ZIEGELBAUER SEPTIC SERVICE LLC

Here is a list of things that need addressing for the septic system located on the property at: 310 North Turtle Bay Road, Elkhart Lake, WI 53020;

Private Onsite Wastewater Treatment System Evaluation

Site Diagram

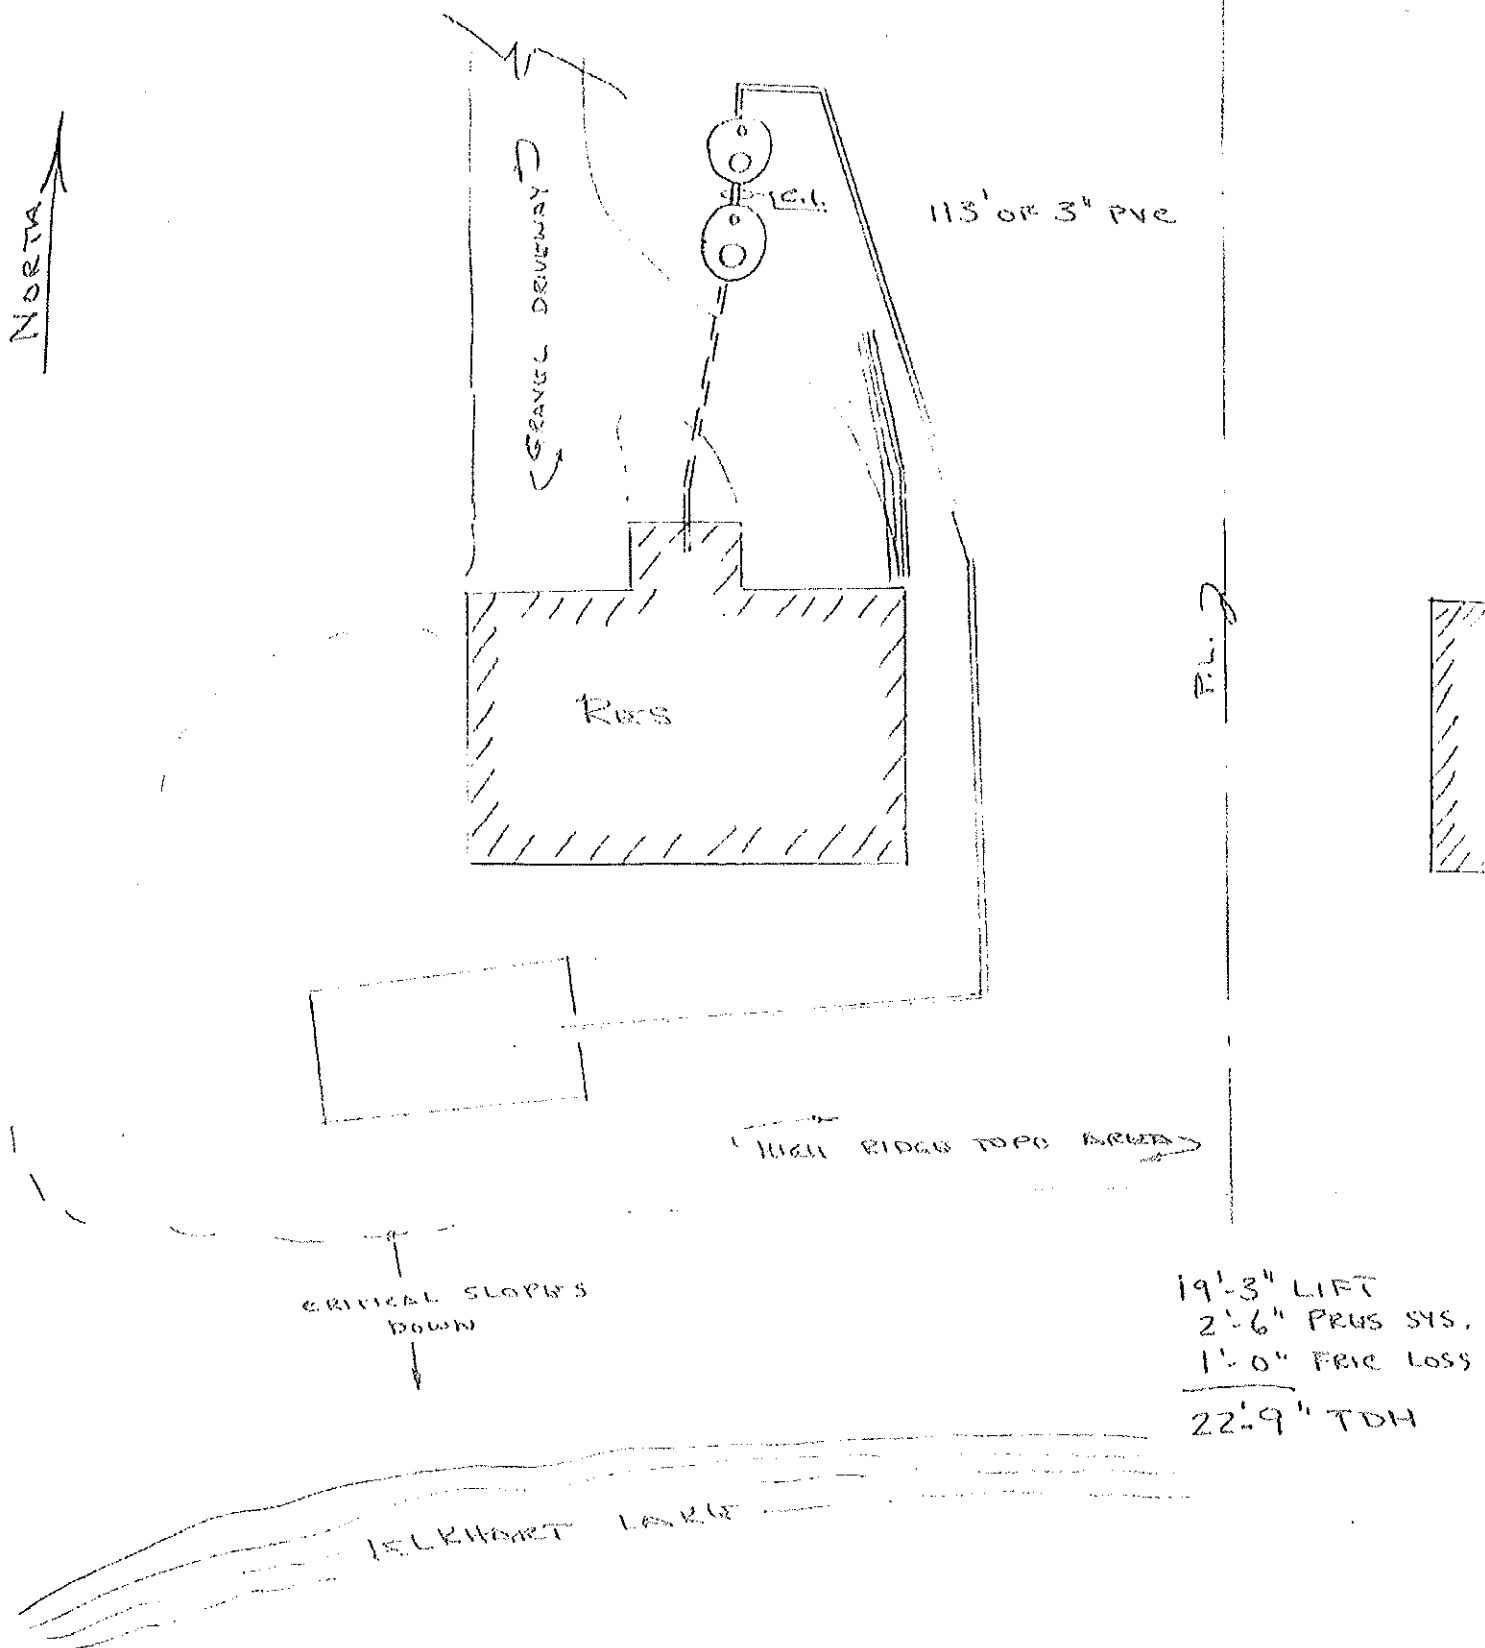
- Do to the 'lift pump' taking a lengthy time of recycling for dosing purposes, the ends of the absorption laterals should be located. Turn-ups are recommended to be installed. And then flushed with a pressure test preformed.
- Electric junction box is cracked and no longer is water-tight. To make this code-compliant, junction box needs be replaced.
- Lift-tank (PC manhole) cover has a chipped out piece and should be replaced.
- High water alarm wire is running thru a joint between the riser and tank lid. This is not code compliant and needs be redone/rewired.
- We no longer go inside residential homes, due to Covid. Therefore it could not be determined if the high water alarm is operable.

Comments: Note: effluent pump was cycled 1-time; it took approx. 45-mins to cycle the pump 1-time.

• Could not locate observation towers
